COMPONENT ALTERNATIVE

AS DESIGNED - MCC

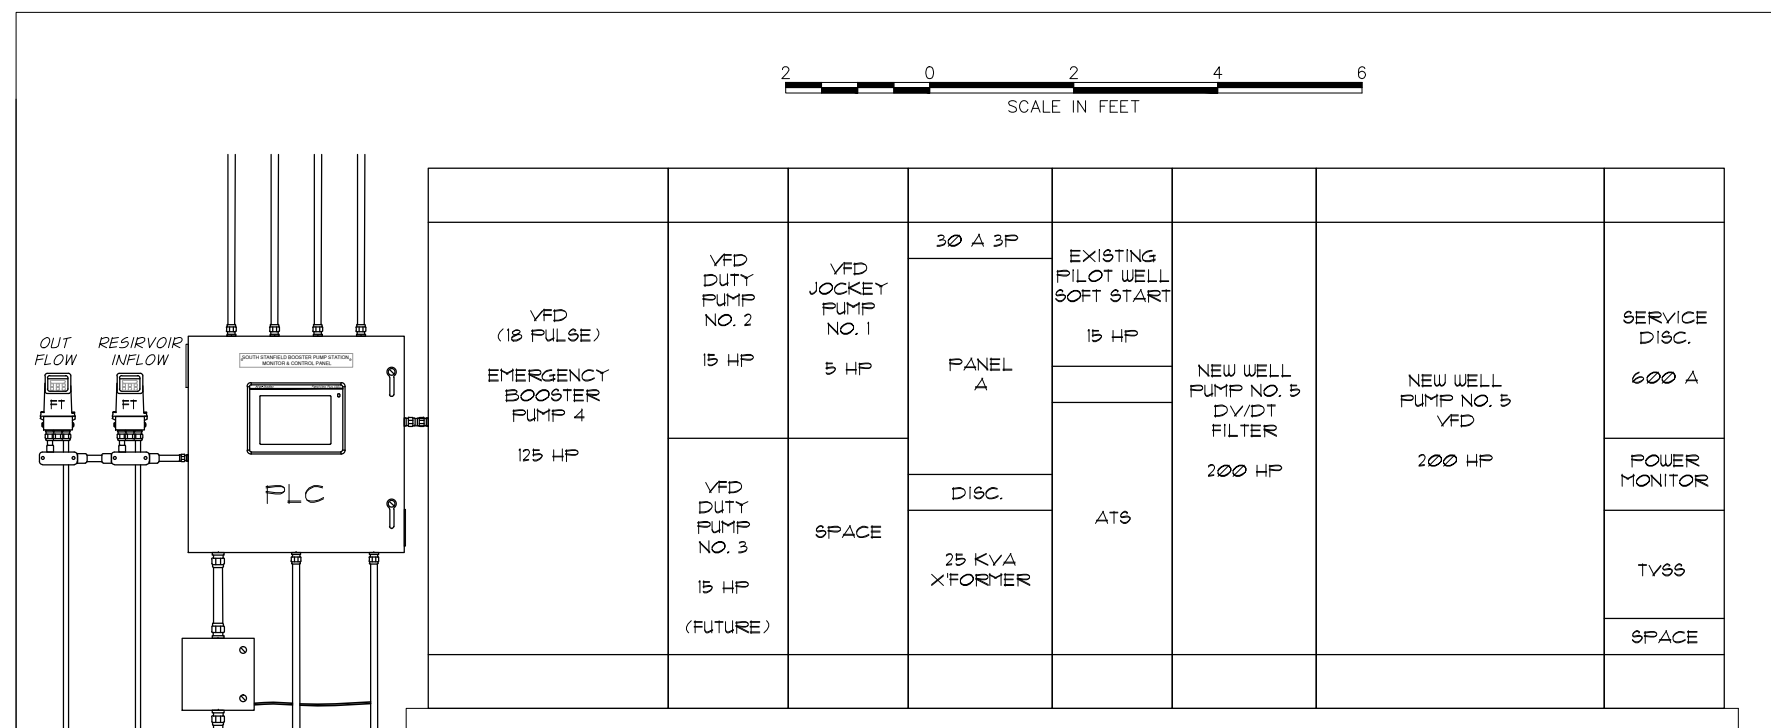
ADDITIONAL CONDUITS REQUIRED (NOT SHOWN)

PLC RELOCATED. CONDUITS REQUIRED PLC ENCLOSURE TO:

- 1) POWER MONITOR
- 2) NEW WELL NO. 5 VFD
- 3) PILOT WELL SOFT START
- 4) AUTOMATIC TRANSFER SWITCH (ATS)
- 5) JOCKEY PUMP VFD
- 6) DUTY PUMP NO. 1 VFD
- 7) DUTY PUMP NO. 2 VFD
- 8) EMERGENCY BOOSTER PUMP VFD
- 9) PANEL A

REQUIRED POWER CONDUITS:

- 10) SWITCH BOARD B TO HEATERS
- 11) PANEL A LIGHTING CKT.
- 12) PANEL A CHLORINATION ROOM
- 13) PANEL A RECEPTACLE CKTS NORTH
- 14) PANEL A RECEPTACLE CKTS SOUTH
- 15) PANEL A ATs - GEN BLOCK HEATER
- 16) PANEL A CATHODIC PROTECTION
